CITY OF SAUSALITO
420 Litho Street, Sausalito, CA 94965

Addendum No. 2

Issued **February 2, 2026**

EDWARDS AVENUE SLOPE STABILIZATION

2 PRODUCTION GROUND ANCHOR (NO SCALE)

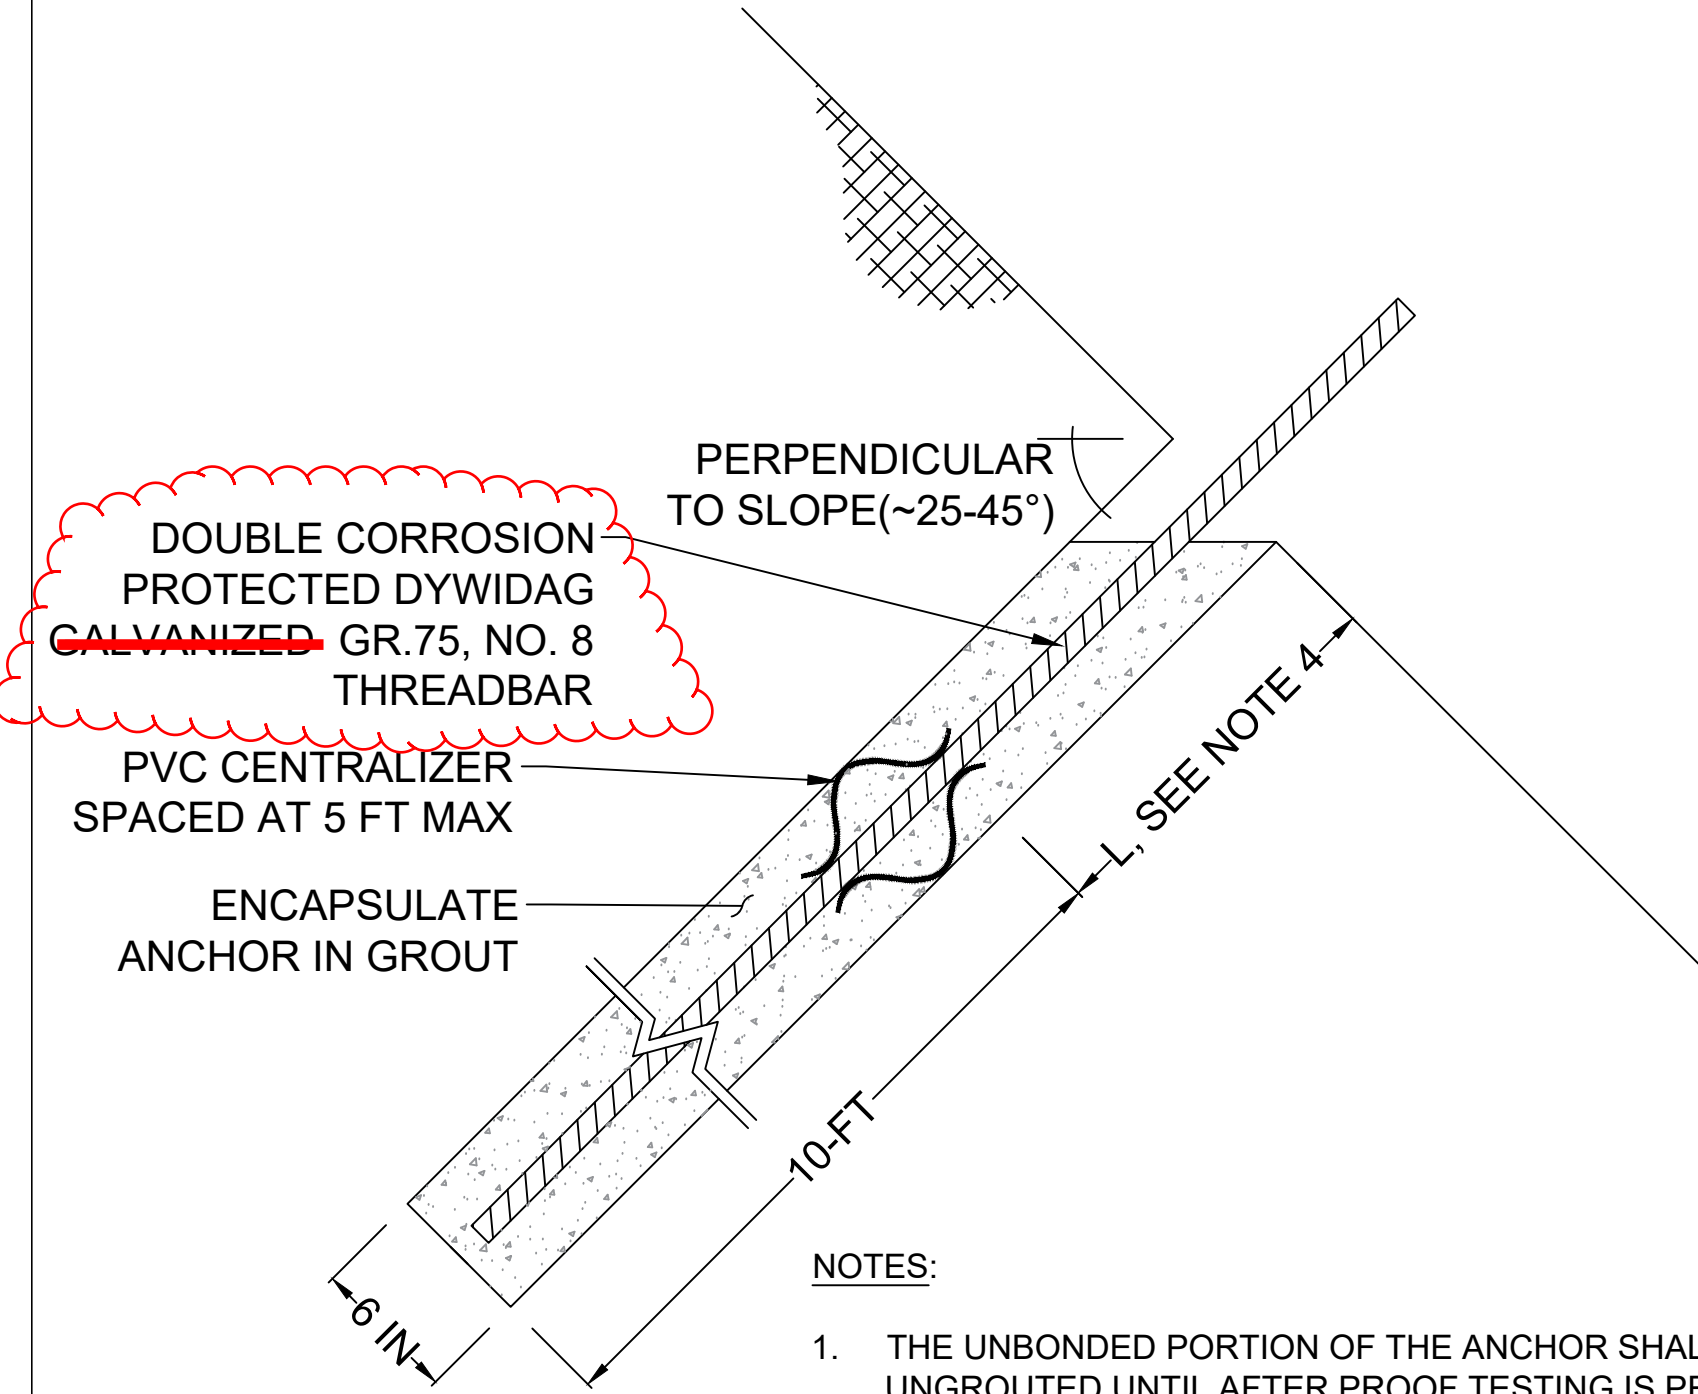
Sheet 5, Detail 2/5 Production Ground Anchor and Detail 3/5 Verification Ground Anchor are revised as shown on the attached Addendum 2 Sheet 5.

DOUBLE CORROSION PROTECTED DYWIDAG GALVANIZED GR. 75, NO. 8 THREADBAR WITH THREADED ANCHOR HEAD
